**Title: QUALITY AUDIT  
INCLUDING ROAD SAFETY AUDIT (Stage 1)  
For;  
Proposed Residential Development and Road Upgrade,  
Boherboy, Saggart, Co. Dublin.**

**Report reference: 1151R01**

**VERSION: FINAL (February 2022)**

Drawing p200107X-PIN-XX-Dr-D-0011-SI Rev P01

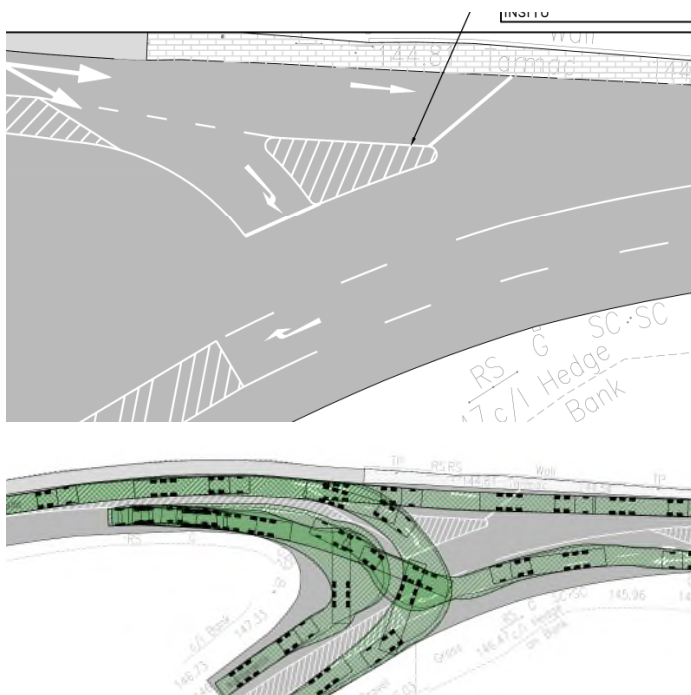
There is a risk of overshoot of the stop line at the N81 junction for eastbound drivers on Boherboy Road. This could lead to rear end or side-impact collisions with eastbound traffic on the N81. In addition the proposed straight ahead arrow may suggest drivers have priority to proceed.

It is recommended that a buildout be provided at the existing footpath into which some signage or other feature be provided to alert drivers that it is not a through route and which will force drivers to approach the N81 at a less acute angle. The straight ahead arrow should be removed.

Drawing p200107X-PIN-XX-Dr-D-0011-SI Rev P01, Boherboy Road, Chainage 740

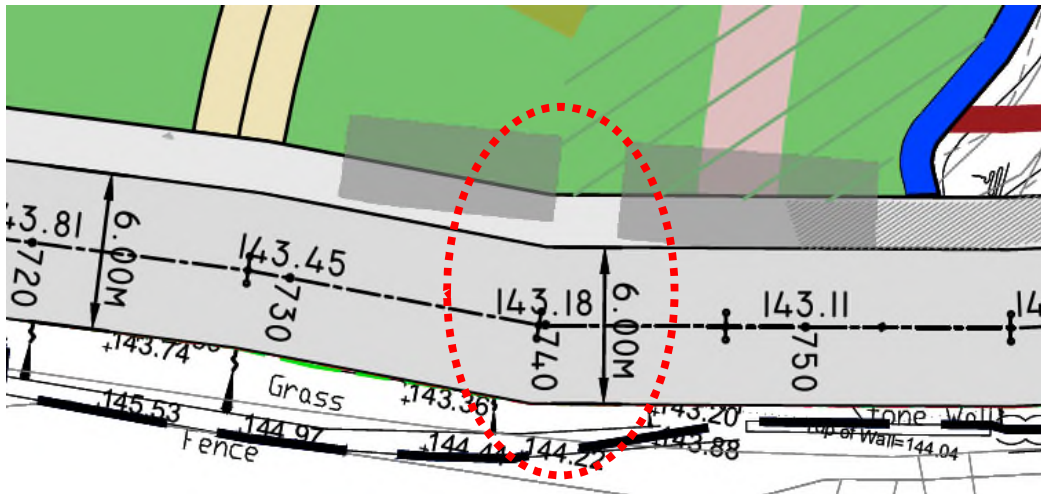
There is a 'kink' in the horizontal alignment of Boherboy Road at chainage 740. This could lead to overrun of the centre line and side-swipe collisions.

Ensure there is a smooth horizontal alignment with a series of curves of suitable radii be provided without straight sections joining.

Drawing p200107X-PIN-XX-Dr-D-0011-SI Rev P01, Boherboy Road, Chainage 70 to chainage 440.

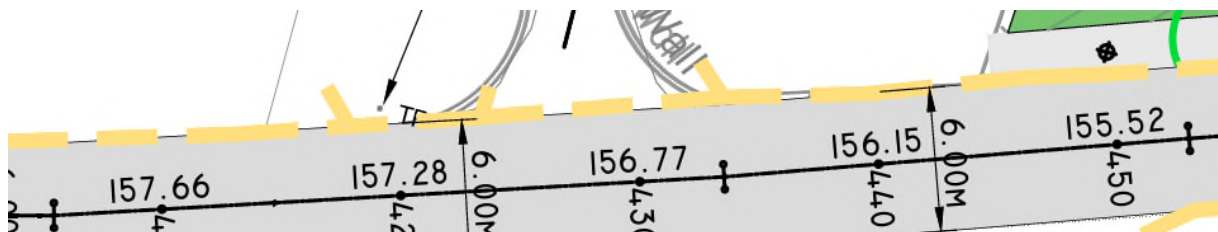
There is a discontinuity in the footway provision on Boherboy Road between chainage 70 and Chainage 440 due to land ownership constraints. The road is being realigned and widened to have a constant cross sectional width of 6m. There is a risk that the proposed development will lead to an increased usage of Boherboy Road by pedestrians wishing to travel to Saggart village, leading to a higher likelihood of a collision with vehicular traffic. It is proposed to provide a raised rib line along the section without a footway. There is a risk that the raised rib line will not be provided due to the noise effects on local residents.

It is recommended that the carriageway be marked narrower than 6m and that the verge be provided flat and level with the carriageway so that pedestrians will have refuge. In areas of wider road bed, vegetation should be cleared to provide additional refuge.

Drawing p200107X-PIN-XX-Dr-D-0032-SI Rev P01, Corbally Heath

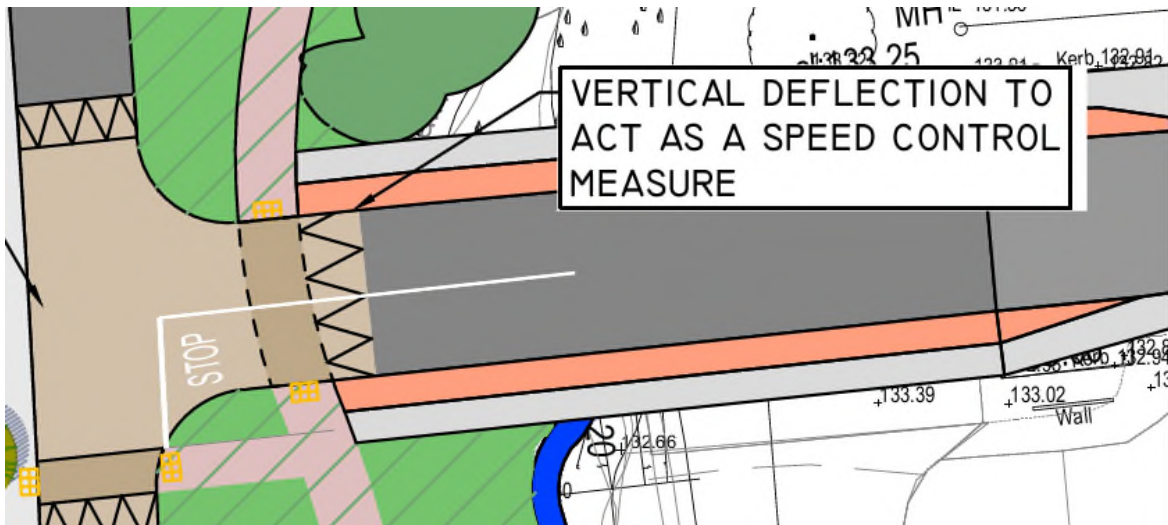
It is proposed to provide a shorth length of cycle track at the connection to Corbally Heath. There are no dedicated cycle facilities either side of this short section. This could lead to cyclists weaving into and out of traffic and sharing space with pedestrians that are not wide enough for both users.

It is recommended that the short section of cycle track be omitted.

Drawing p200107X-PIN-XX-Dr-D-0032-SI Rev P01, Corbally Heath

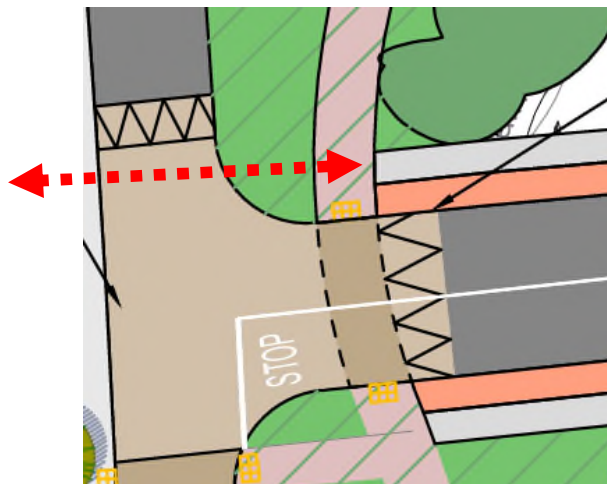
There will be a pedestrian desire line from the footpath on the northern side of Corbally Heath to the footpath on the opposite side of the internal development road.

It is recommended that a pedestrian crossing similar to the south side of the junction be provided.

Drawing p200107X-PIN-XX-Dr-D-0033-SI Rev P01, Carraigmore.

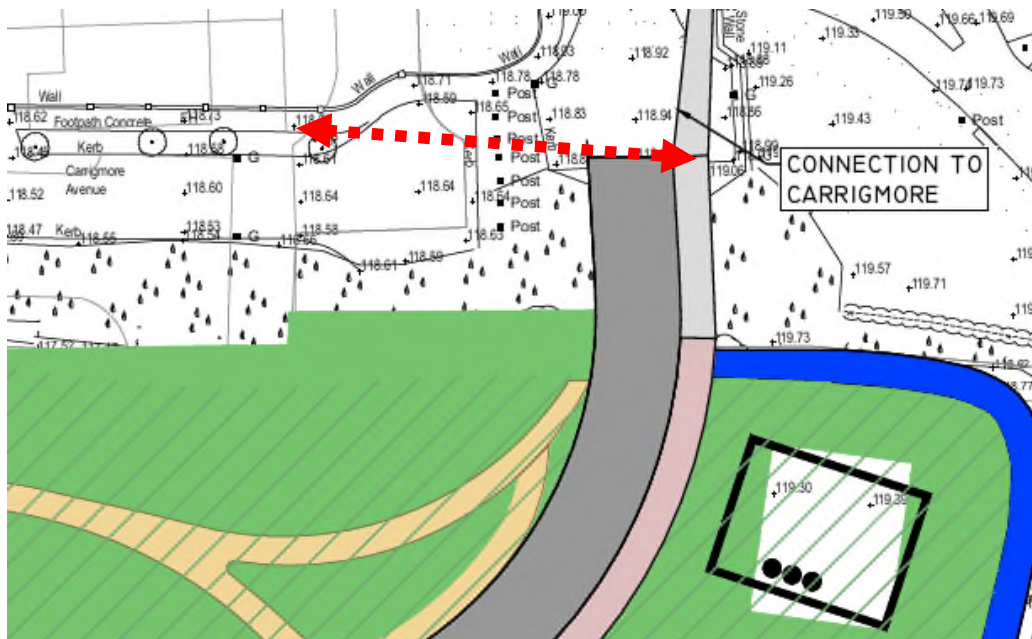
There is an existing pedestrian desire line from Carraigmore Green to Carraigmore Avenue. The demand will increase when the proposed development is fully occupied and this pedestrian desire line should be facilitated as an alternative pedestrian route to Saggart village rather than Boherboy Road.

It is recommended a pedestrian link to Carraigmore Avenue be provided.

Drawing p200107X-PIN-XX-Dr-D-0034-SI Rev P01, Culvert protection.

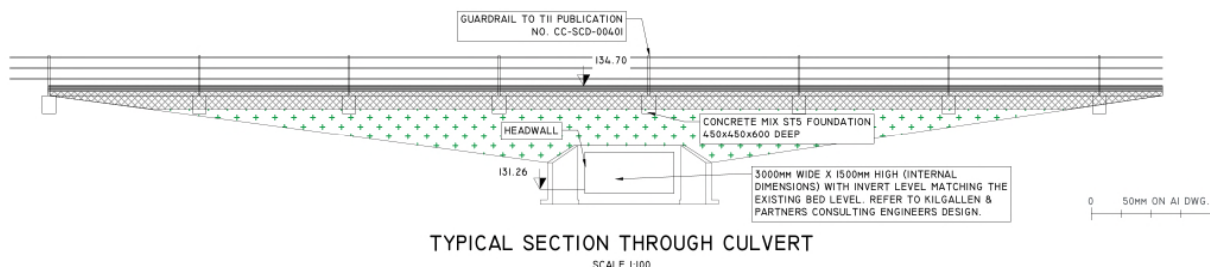
A railing in accordance with TII Standard Detail CC-SCD-00400 has been referred to on the drawing as containment at the bridge structures. It is unclear if this will provide adequate containment to errant vehicles.

It is recommended a risk assessment be carried out to ensure sufficient containment is being provided at the bridges/culverts.
